Re: Chino Administrative Order on Consent (AOC)
Feasibility Study for the Smelter Tailings Soils Investigation Unit

Freeport-McMoRan Chino Mines Company – Administrative Order on Consent Response to New Mexico Environment Department Comments on the Smelter Tailing Soils Investigation Unit Feasibility Study

This document presents Freeport-McMoRan Chino Mines Company's (Chino) response to comments on the Feasibility Study (FS) for the Smelter/Tailing Soils Investigation Unit (STSIU), dated October 3, 2026. The comments were received from the New Mexico Environment Department (NMED) in a letter date January 28, 2026. The FS was prepared in accordance with the Scope of Work associated with the Administrative Order on Consent (AOC) between Chino and NMED. The FS has been revised to address NMED comments and the below provides Chino's response in *italics* to each of those comments.

FIGURE 8-1

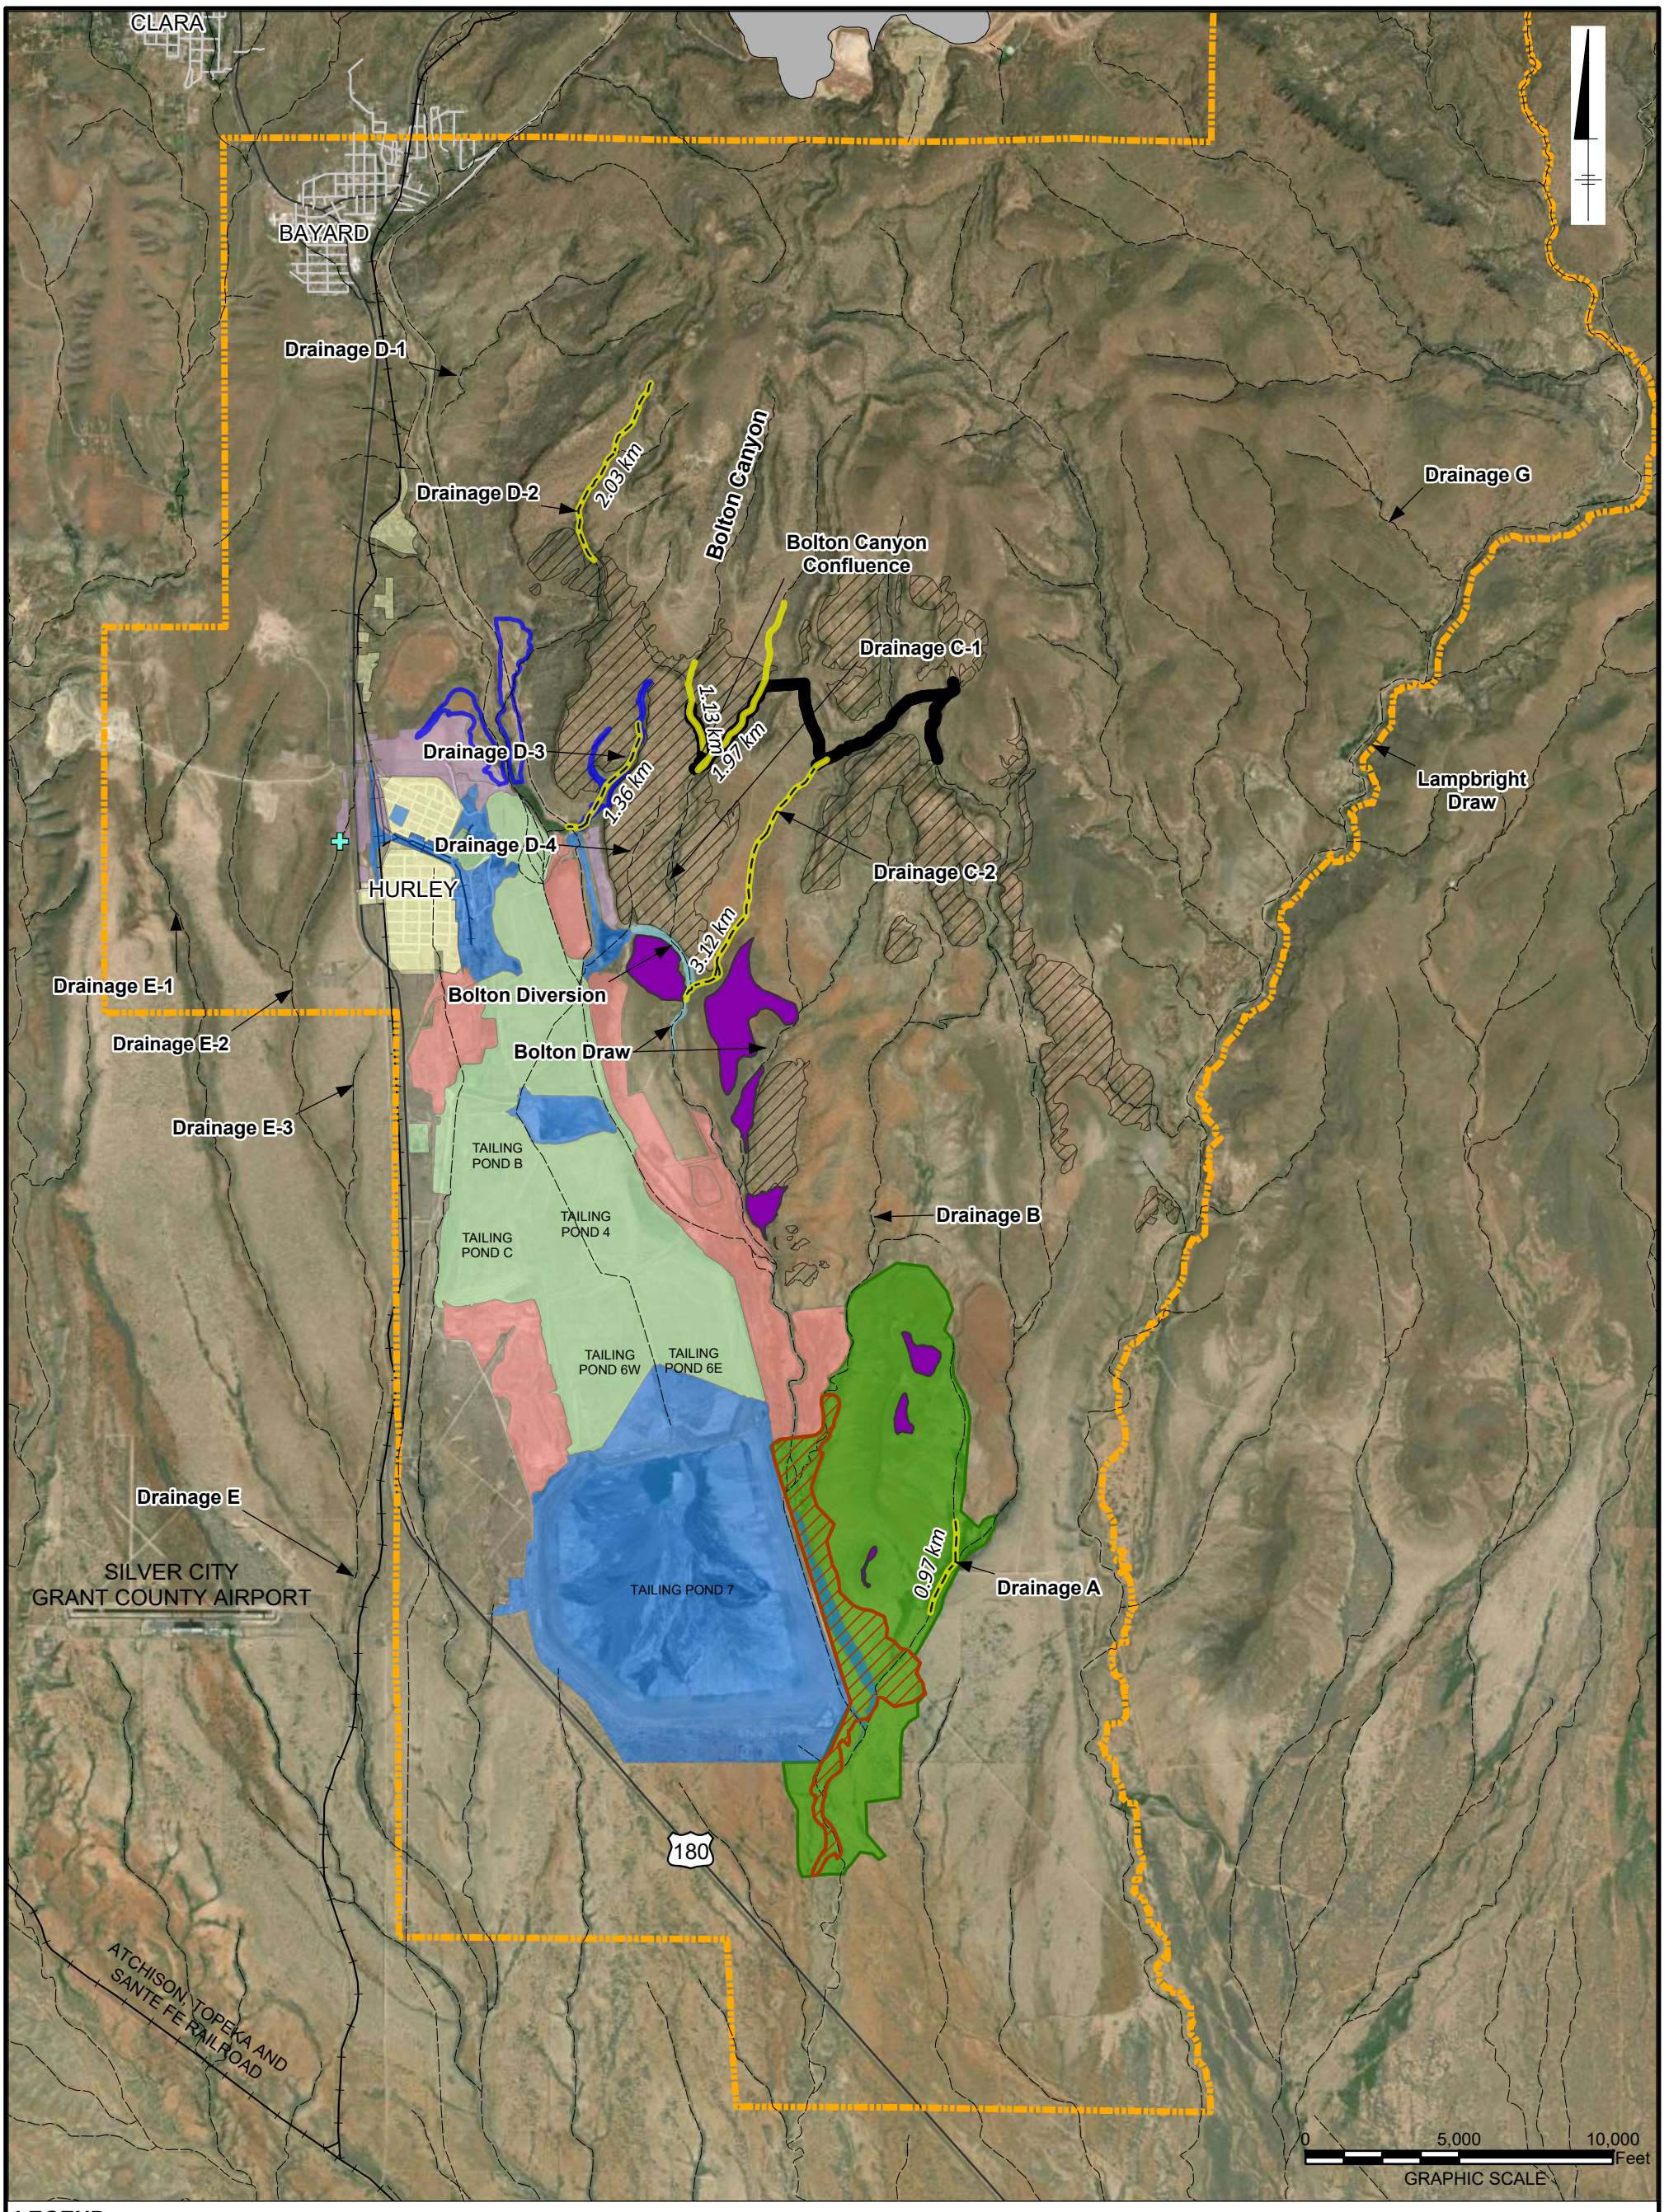
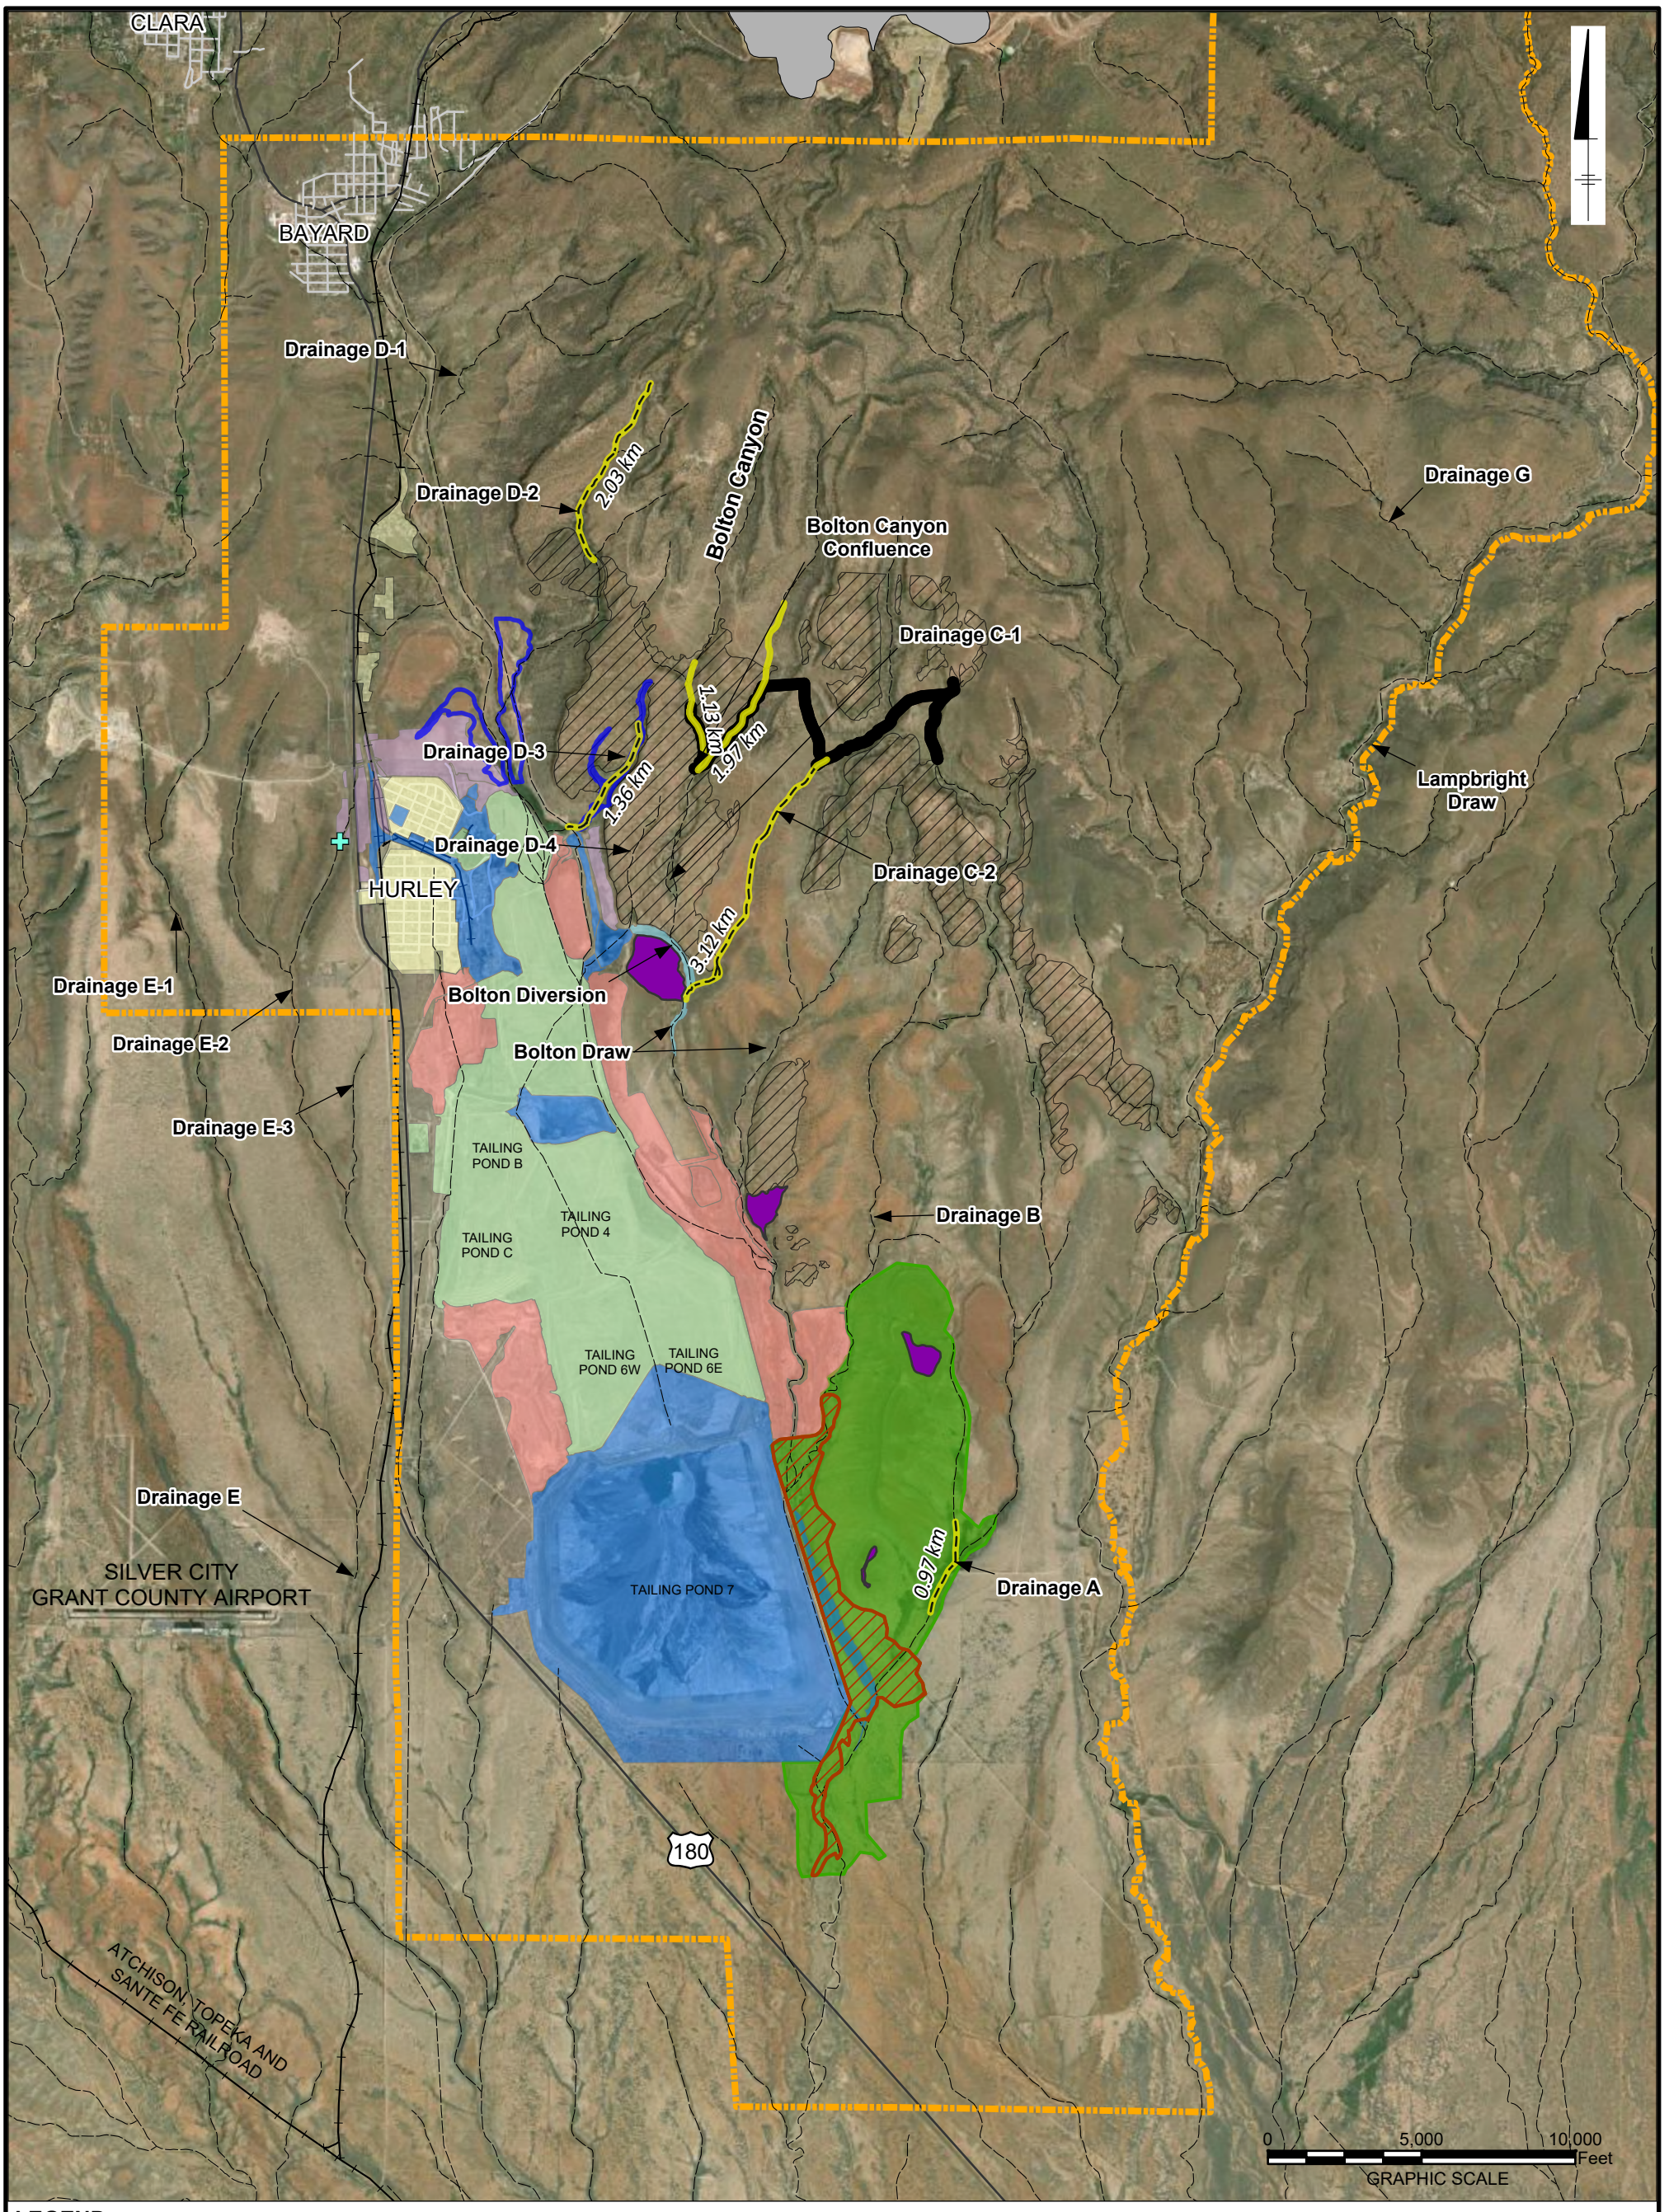
NMED Comment #37. Please make the following adjustments to the text in Page 7.3.1.1 on Page 65. Please change the text to "The No Action alternative would not reduce predicted risks to human health and the environment, nor would it harm human health and the environment for areas with pCu between 4.6 and 4.98 (which are the areas that differ for the pCu remediation areas between Figures 8-1 and 8-2).

Chino Response: *The requested change has been made to the report.*
